Solicitation No. - N° de l'invitation l'acheteur EQ754-212348/A	Amd. No. - N° de la modif. 08	Buyer ID - Id de PWL003
Client Ref. No. - N° de réf. du client FMS No./N° VME R.080037.042 R.080037.032	File No. - N° du dossier PWL-0-43060	CCC No./N° CCC -

Questions and Answers:

5a  
A-9

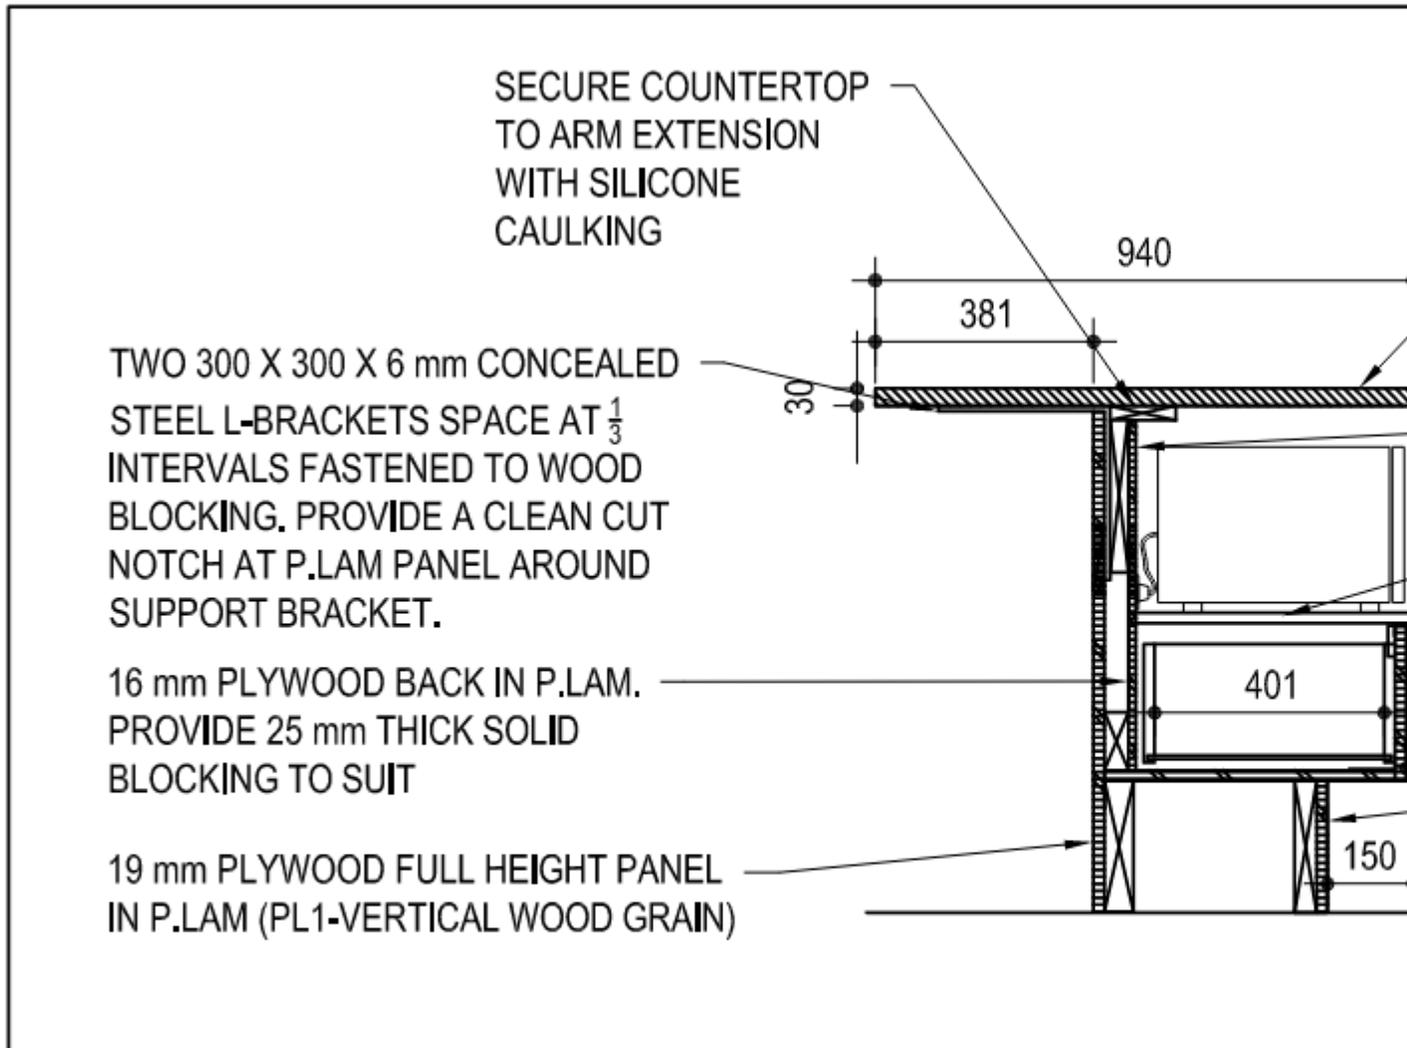
Elevation 2/A-9 implies solid surfacing countertop, on seating side of the island, to be 25mm thick returning to the floor on each end of the island (waterfall).

25mm total thickness would be 12mm solid surfacing on 13mm backing, but referenced Sections 5a/A-9 and 5b/A-9 both indicate the backing for the countertop as 19mm plywood not 13mm and only one colour of one Manufacturer of solid surfacing is offered in 6mm thickness. Please review and advise.

Q: At dimensions of  $\pm 3m$  and a depth of more than 450mm such is greater than what the 25mm thick countertop will be able to span, regardless of if this is to be 6mm on 19mm, 12mm on 13mm, or 12mm on 19mm. The Designer should be considering a deeper profile for the countertop, or less projection or a mid-span gable / support. Please review and advise.

Q: If solid surfacing at 25mm such would not include for a backing material and would not be recommended given depth of the overhanging counter, and may be affected by the Designers reconsideration of the depth of the countertop, reduction in the depth of the projection and / or provision of additional mid-span support. Please review and advise.

- There is an double-ended arrow, oriented horizontally, on the unknown surface in the knee space. Neither referenced Sections 5a/A-9 or 5b/A-9 indicate the nature of the construction below the countertop or finishes applied to whatever the surface is. The arrow symbology is commonly used to indicate the direction of the grain or pattern of a finishing material, but the Elevation and Details do not provide any indication what the product / surface is and if such is for the purposes of establishing a grain or pattern direction.

- Elevation 3/A-9 indicates the depth of the countertop as 25mm with and additional 25mm space before the top edge of the openings for the microwaves / recycling centre pull out drawers.

- Referenced Sections 5a/A-9 and 5b/A-9 both indicate a deeper (scales as 106mm) and different configuration to the vertical return face of the solid surfacing countertop. Both are detailed at scale of 1:20. Which way are we to consider for pricing?

- What is the construction of the wall separating the two sides of the island, including the construction of the elements supporting the countertop on the microwave / recycling centre pull-out drawer sides of the island? Appearance is this is to be a 92mm deep metal stud framed / gypsum wallboard finished part height partition with 64mm deep metal studs horizontal framing for the countertop. Please review and advise.

Q: Is there to be a finished surface within (top, bottom, back & sides) and between each of the open microwave spaces, and if so what is the product finish? Please review and advise.

Q: What part of Detail 15/A-9 applies to the junction between the open microwave shelves to the drawer below?

Q: What is the horizontal depth of the kneespace, the thickness of the supporting partition, and cabinet? The dimension for the countertop, at 1050mm wide, along with the depth (391mm) of the recycling centre pull-out drawers, are understood but there are no other horizontal dimensions to work with. Please review and advise.

A: Refer to updated section below.

A: Refer to updated section below.

A: Refer to updated section

A: Refer to updated section below.

A: Refer to updated section below.

A: Refer to updated section below.

A: Refer to updated section.

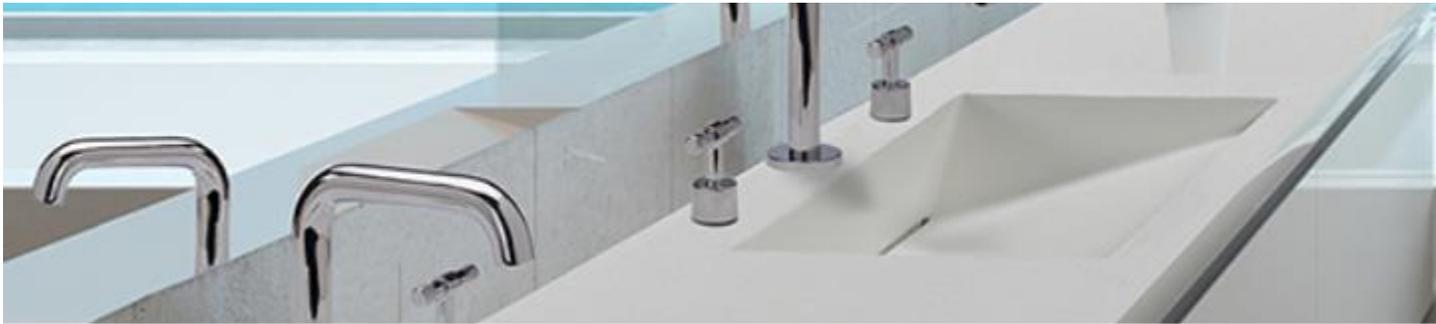
**Q:** Men's and Women's Washroom Vanities

Section 12/A6.3 is woefully inadequate to determine a cost, the configuration does not match what the Plan Details and Elevations are indicating (depth from front edge of counter to edge of bowl / trough, that the 33x3x4 horizontal HSS under the counter (presumably spanning the width of the counter and supported by the 2x38x89 solid wood posts each end) would be visible below the counter but not shown in the Elevations)

**Q:** and is not coordinate with the Mechanical Drawings that indicate 4 individual LAV-1 bowls for each of the two washrooms. If the Mechanical Drawings are wrong, that these are to be troughs with, perhaps, four drains per trough, then the Architectural Details need to provide greater clarity and detail to the configuration of the trough, not whatever is currently indicated in this Section, but if the Mechanical is current, that there will be 4 individual bowls per vanity then the Architect needs to provide a model number

**Q:** dimensions of the bowl. The Section provides no indication of the extent of the solid surfacing materials or any backing requirements. Please review and advise.

**A:** Elevation 7/A-6.3: provide continuous hss section along front edge of counter

**A:** Being a performance-based spec, model numbers were not provided. Bowl to slope from ±25 mm to ±100 mm deep. Confirm depth with manufacturer's recommendations for

**A:** Integral Sinks: standard sink design formed integrally with countertops as per Spec Section 12 36 61. Remove mechanical's 4 sinks. Disregard sink section of 12/A6.3. Follow size dimensions on 11/A6.3. Sloped profile similar to image referenced.

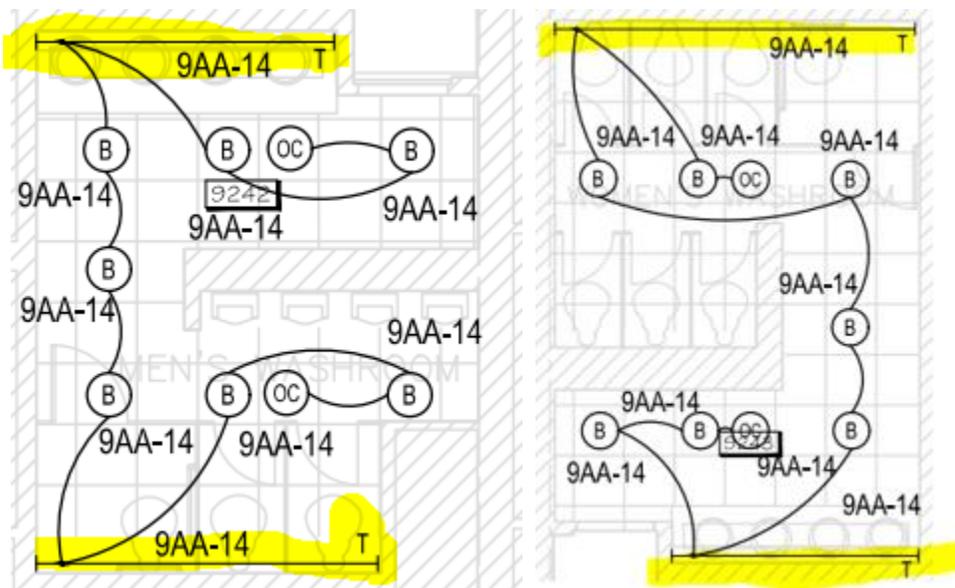
Q: In both the washroom, lighting fixture T is present. Confirmation is required whether these fixtures are type T or type D. If type T, please arrange to provide the specification for it.

A: Type T light fixtures in both washrooms are existing to remain. Refer to electrical demolition legend.
